**15-DAY EXPRESS TERMS
FOR
PROPOSED BUILDING STANDARDS
OF THE
OFFICE OF THE STATE FIRE MARSHAL

REGARDING PROPOSED CHANGES TO
2016 CALIFORNIA BUILDING CODE
CALIFORNIA CODE OF REGULATIONS, TITLE 24, PART 2**

**CHAPTER 35
REFERENCED STANDARDS**

~~FIGURE 11.2.3.2.3.1 Design Area Reduction for Quick Response Sprinklers.~~

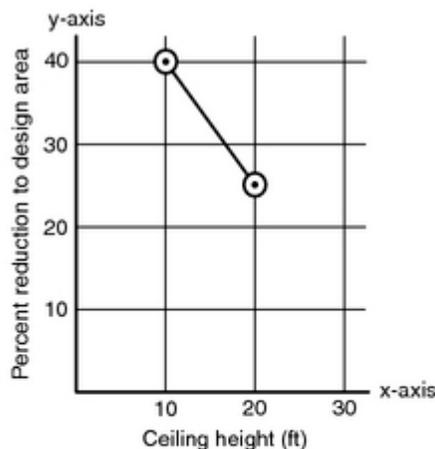
Note: $y = \frac{-3x}{2} + 55$

For ceiling height ≥ 10 ft and ≤ 20 ft, $y = \frac{-3x}{2} + 55$

For ceiling height < 10 ft, $y = 40$

For ceiling height > 20 , $y = 0$
